EBC Ref: F/25/100141 – Kings Copse Avenue: Transport Assessment Addendum

Ref: OT/ITS19785-019
Date: 12 December 2025

- 1.1 This Transport Assessment Addendum (TAA) has been prepared to address comments raised by Hampshire County Council (HCC) in their response (*ref: 058151*) to the Transport Assessment submitted as part of the full planning application for 192 dwellings on Land South East of Kings Copse Avenue (*ref: F/25/100141*).
- 1.2 The comments raised by HCC are included as **Appendix A** and have been grouped into three categories as follows:
- 1 Vehicle Access
 - 2 Pedestrian and Cycle Access
 - 3 Internal Layout
- 1.3 The TAA responds to queries raised by HCC in turn in each category. It is noted that the response from HCC reviewed and raised no objection to the traffic impact (i.e. trip generation / distribution / junction modelling) of the proposed development and therefore no additional information has been provided regarding this element.

Image 4.1: Central Square – Updated Site Layout.

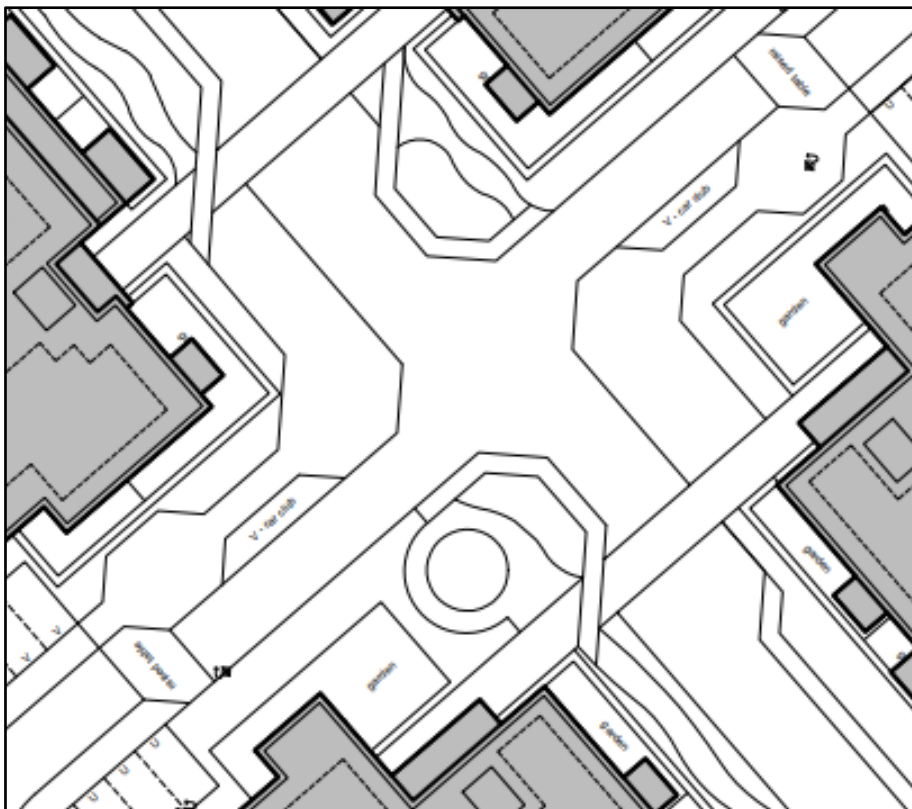
Having reviewed these, it is noted that whilst the refuse vehicle can negotiate the majority of the side, there are points where vehicle body overhang takes place (i.e. to the west of plot 1, west of plot 6, north of plot 10, west of flat block B01, and north of plot 102).

Whilst it is unclear whether the sites internal road layout are to be put forward for adoption, either in part or full, it should be noted that such instances of vehicle overhang would not be acceptable for HCC Highway adoption given there would be no highway control over what could be put on the affected pieces of land, which essentially could be obstructive to the refuse vehicle movements. As such, plans should be updated with localised adjustments made to enable the free movement of the refuse vehicle accordingly.

- 4.1.1 HCC have requested clarification regarding the adoption status of the internal site layout. It can be confirmed that the internal layout will not be offered for adoption as highway and will be under the responsibility of a private management company.
- 4.1.2 The site layout has been updated to amend the 'Central Square' to provide a traffic calmed area to promote low vehicle speeds and promote pedestrian movement. An extract of the updated 'Central Square' is included as **Image 4.1**. The updated design is in accordance with paragraph 7.4.1 of Manual for Streets principles which seek to control traffic speeds naturally through reduction in carriageway widths / removing straight sections of carriageway.

- 4.1.3 The updated site layout is included as **Appendix D**.

Image 4.2: Demarcated area for pedestrians to access boot of their vehicles.

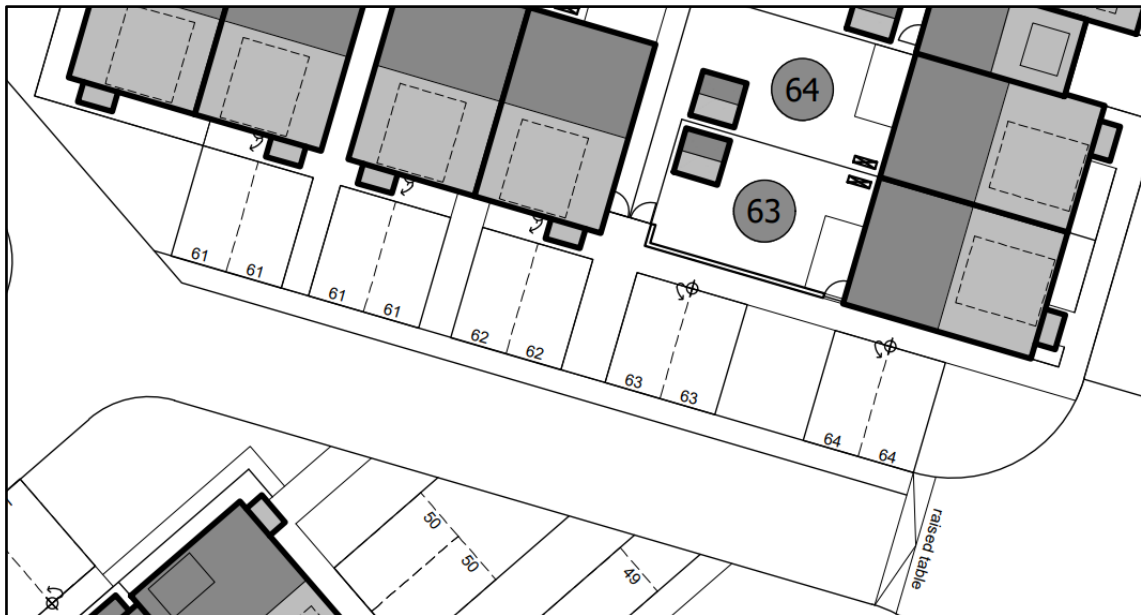
For the same area, and indeed others across the site such as plots 61 to 64, where a relatively high level of passing traffic can be expected, concern is also raised regarding the need for users to stand in the road when taking items from the boot of their vehicle. Vehicle spaces should be indented further inwards to provide a safe standing position off of the carriageway.

- 4.6.1 HCC commented that the proposed parking bays will require pedestrians to stand in the carriageway whilst accessing the boot of their vehicle.
- 4.6.2 This area of the layout will operate as a shared surface arrangement. The site layout has been updated to provide a 1.2m wide strip, which will be demarcated with a different colour, to provide a visual separation between the carriageway and a safe 'standing area' for pedestrians whilst accessing the boot of their vehicle. An extract of this area is shown on **Image 4.2**.

4.6.3 The updated site layout is included as **Appendix D**.

Drawing Title
S278 WORKS - OVERALL SCHEME PLAN

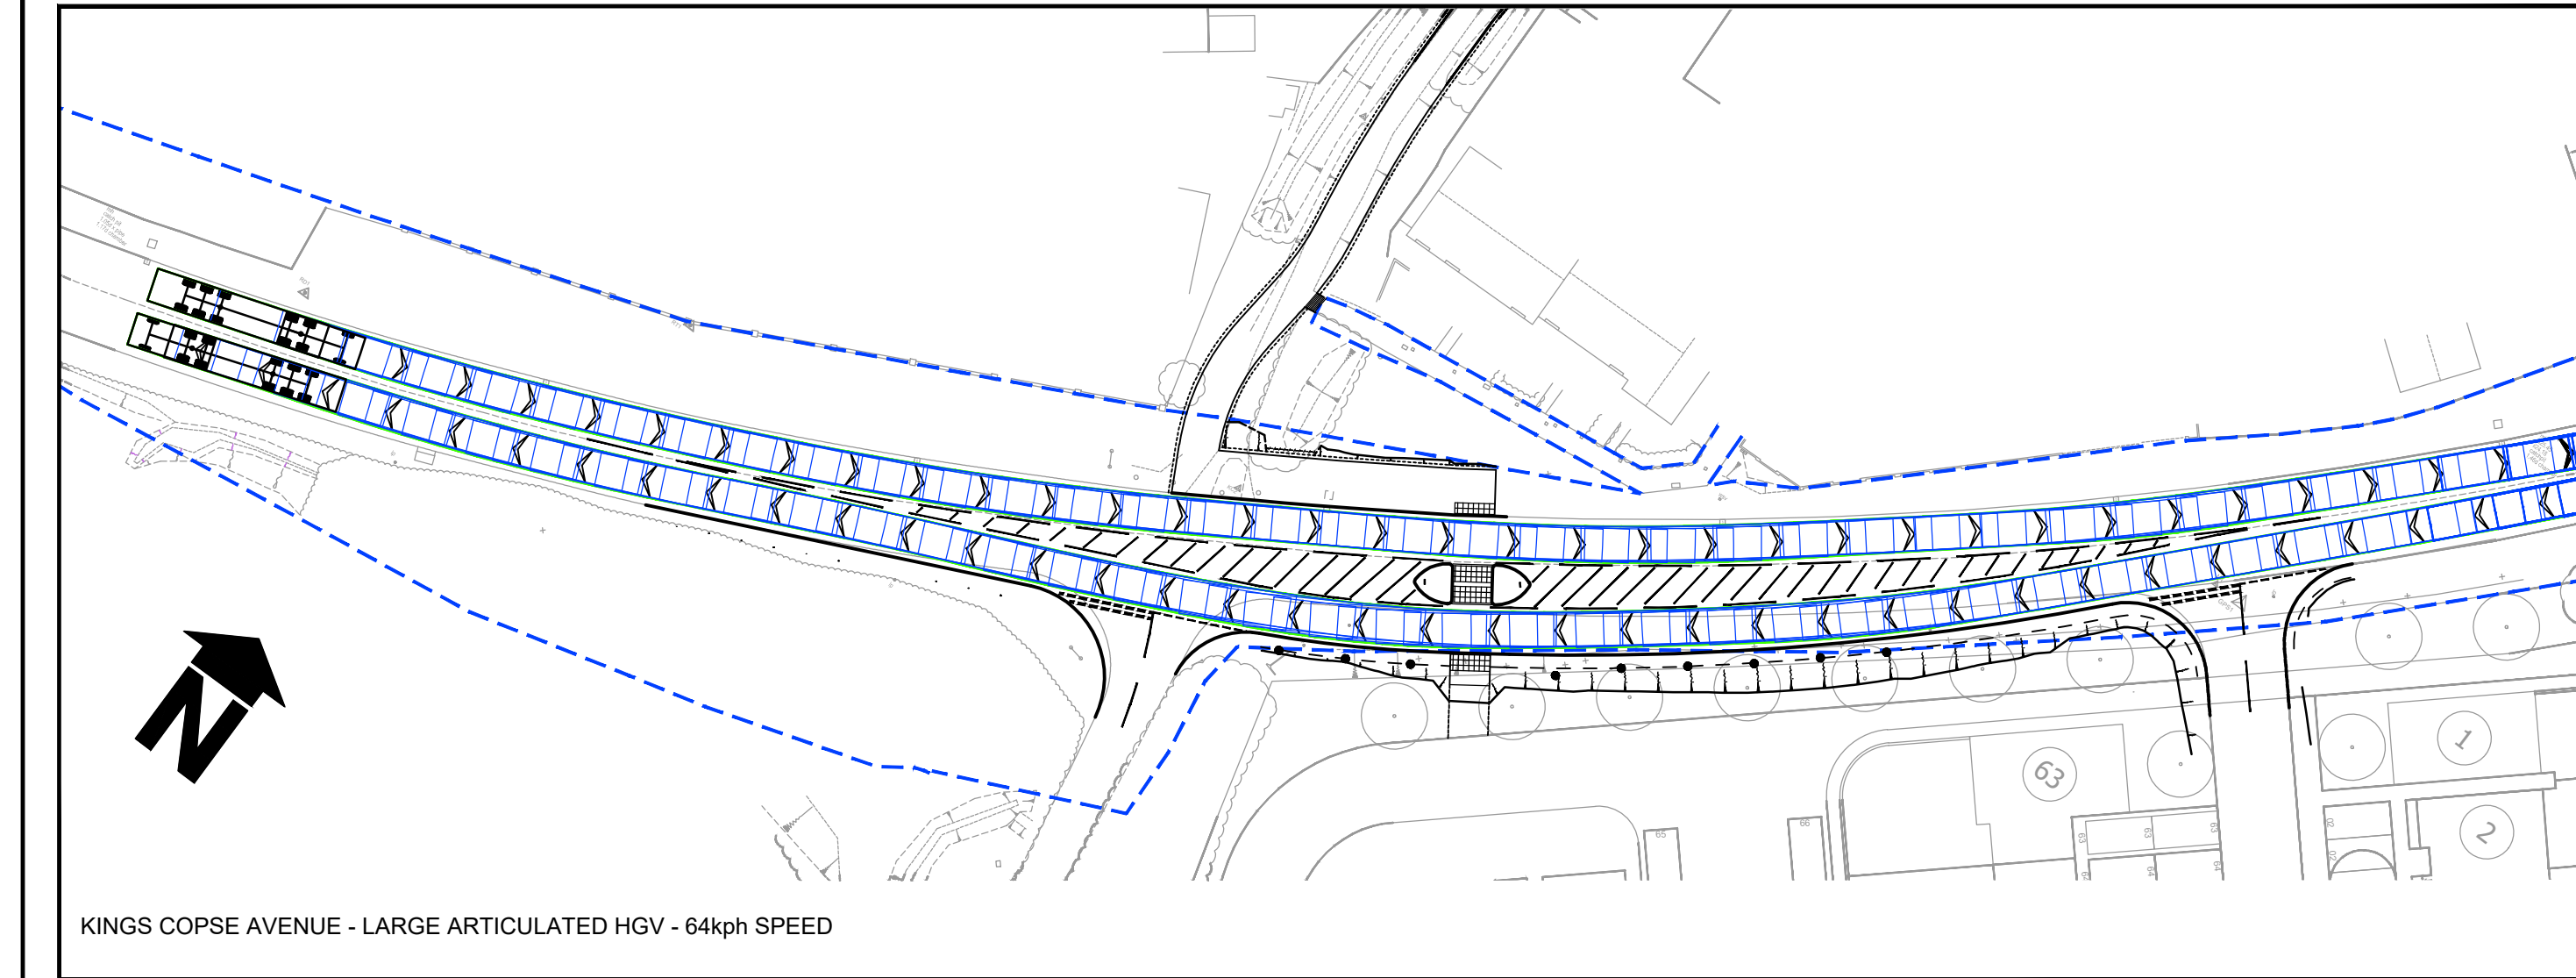
- 2.1.1 HCC have commented that the submitted site access drawing (*ref: 3743.03B*) outlines that visibility splays of 2.4m x 119m and 2.4m x 109m are achievable within the highway boundary, however the drawing itself does not show the full extent of the splays.

In terms of visibility from this junction onto Kings Copse Avenue, whilst the 'S278 Works – Overall Scheme Plan' drawing (3743.03B) outlines that visibility splays of 2.4 x 119.0m north and 2.4 x 109m south are achievable, the drawing itself does not appear to show the full extent of the splay. It is therefore requested that a plan showing the full visibility splay is submitted for assessment, and also for use in conjunction with a condition of planning to stipulate the area within the visibility envelope is kept clear of visual obstruction.

Clarity is also required with link A outlined above. Whilst the S278 Works – Overall Scheme Plan (drawing 3743.03B) appears to show this link as approximately 3.0m wide, the ‘Proposed Pedestrian / Cyclist Connections’ drawing (ITS19785-GA-006 Rev H) outlines the link will be 2.0m wide. The alignment is also different between the two drawings. Clarification is therefore sought on both width and alignment.

- 2.1.2 An updated drawing (ref: 3743.03_RC S278 Works Overall Scheme) has been prepared which illustrates that the full extent of the visibility splays is achievable within the adopted highway boundary. This drawing is included as **Appendix B**.

- 3.2.1 HCC have requested clarity regarding a discrepancy between the S278 Works Overall Scheme Plan (ref: 3743.03B) and the Proposed Pedestrian / Cyclist connections drawing (ref: ITS19785-GA-006H).
- 3.2.2 It is confirmed that the link north-east from the site to the underpass is 2.0m in width. This is shown on the updated drawing (ref:3743.03_RC S278 Works Overall Scheme).

6.2 A revised vehicular access drawing (*ref: 3743.03_RC S278 Works Overall Scheme*) has been prepared to illustrate the full extent of visibility splays of 2.4m x 119m and 2.4m x 109m can be achieved within the adopted highway boundary. Swept path analysis drawings have been prepared for the proposed access arrangements to demonstrate safe manoeuvrability of the access.
